RAI 12.C:

CROW BUTTE RESOURCES, INC.

Technical Report Marsland Expansion Area

Figure 2.9-1 Marsland Expansion Area Preoperational/Preconstruction Monitoring Program Timeline

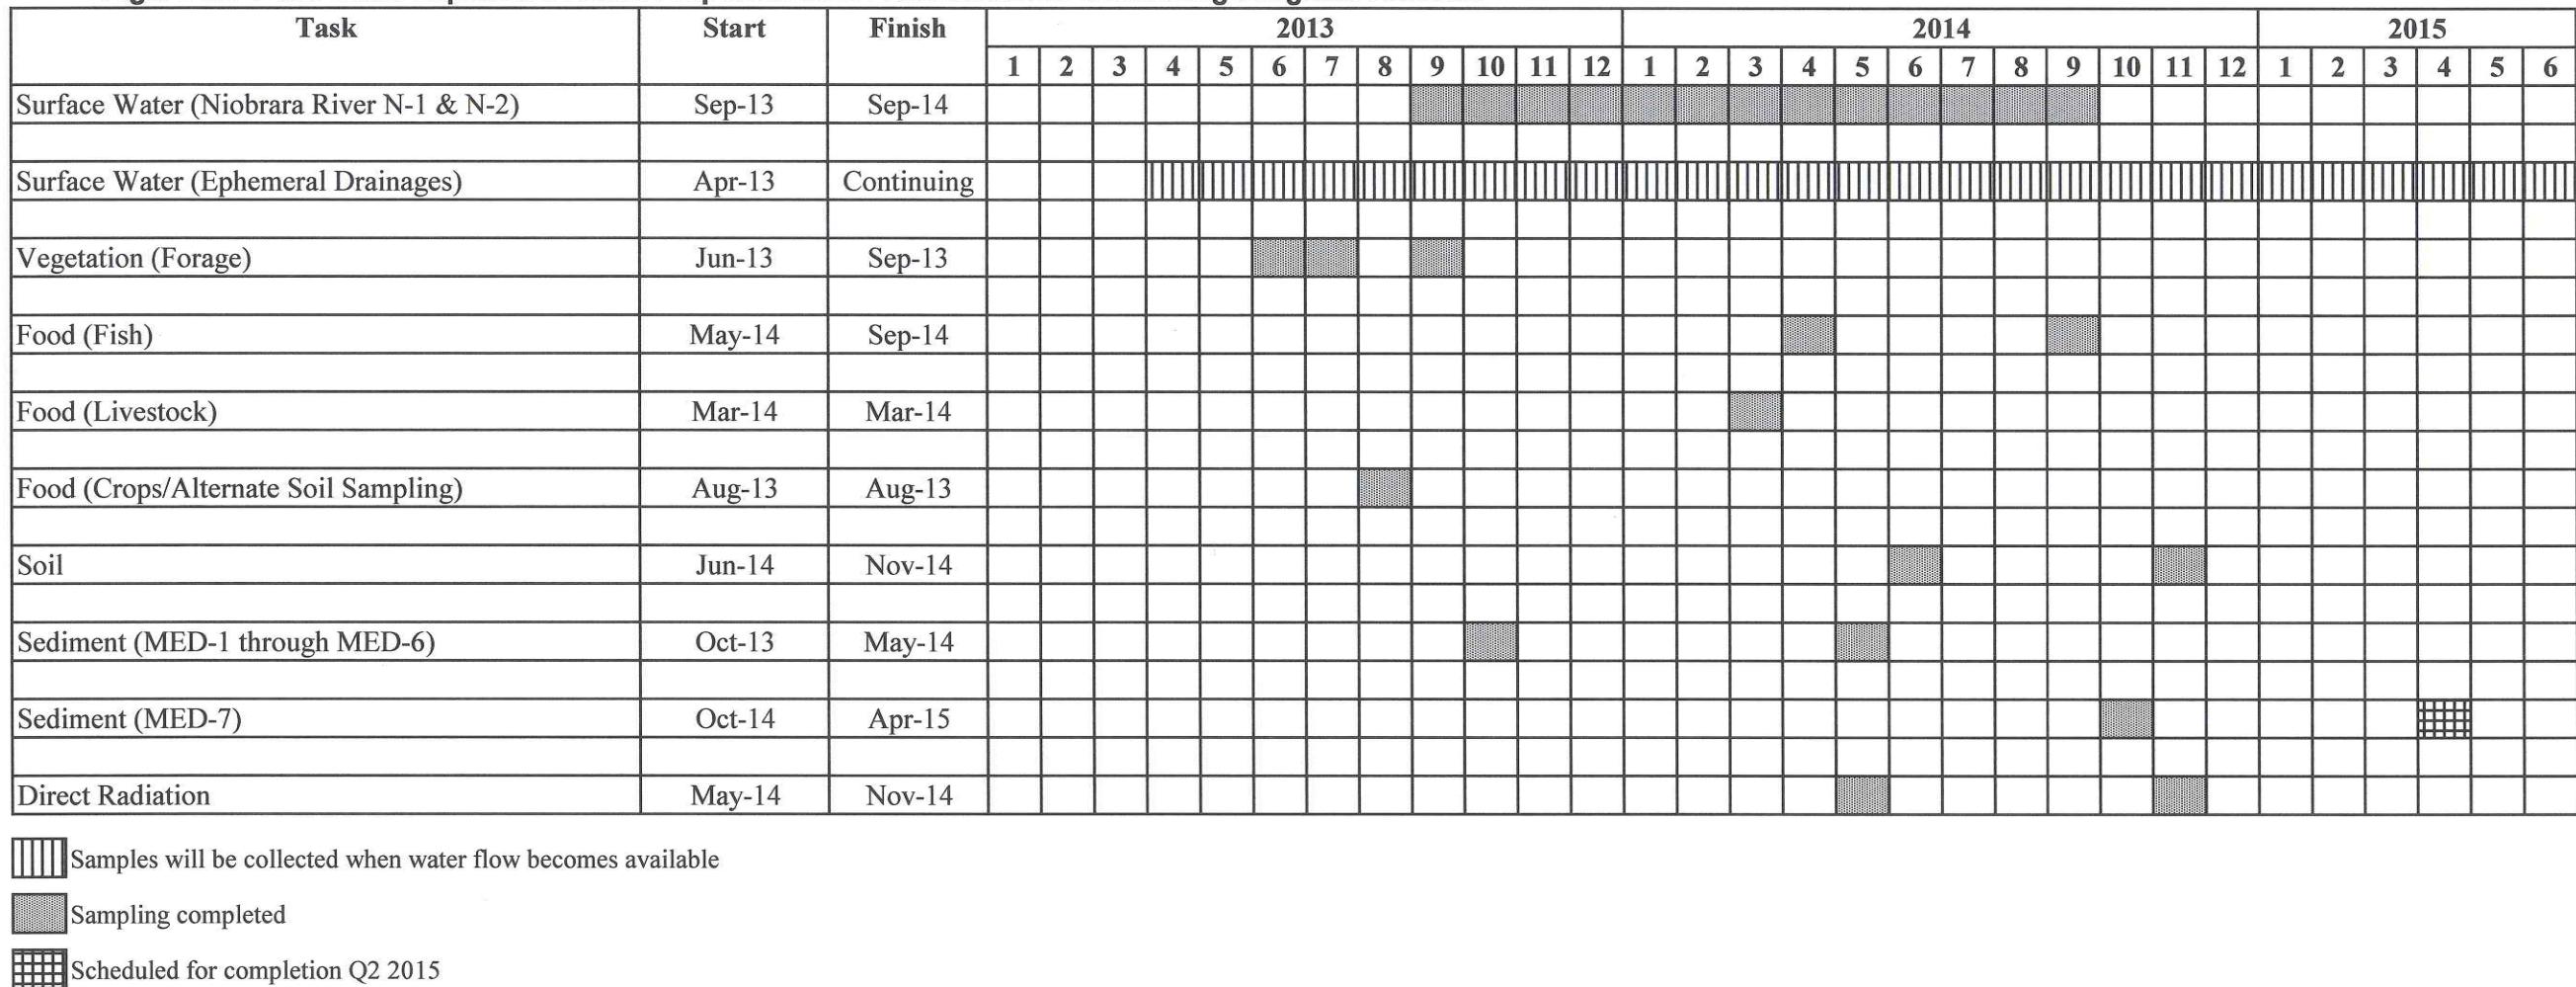
C. Please submit the results of the preoperational/preconstruction monitoring program described in TR Section 2.9, including the survey discussed in TR Section 2.9.5.2, or a revised schedule for these items.

Figure 2.9-1 has been revised to reflect the current schedule.
